Varimixer

New shape

Standardization of knee and foot design across AR30, AR40 and AR60 variants

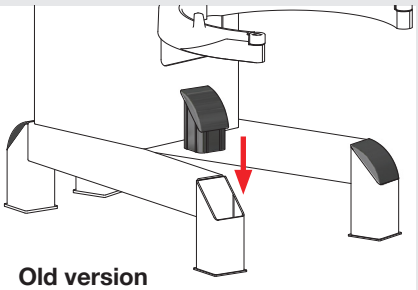
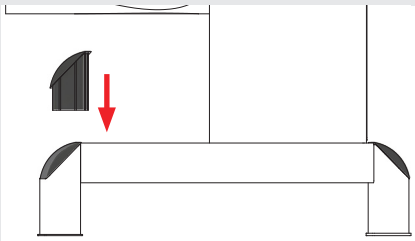
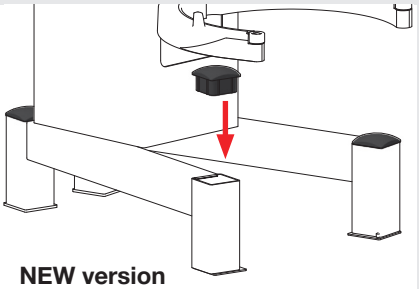
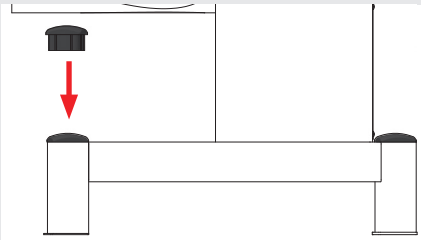
To improve the quality of the plastic knee component through updated mould tooling and a revised design. The new design also provides better coverage of the foot, reducing the risk of water ingress. In addition, the knee and foot design has been standardized across AR30, AR40 and AR60 stands, reducing part variation and simplifying inventory management.

Previously, AR30/40 and AR60 used different component designs. The new common design replaces the previous variants, reducing part complexity and simplifying production, inventory management and service support. Production kits and related BOM structures have been updated accordingly.
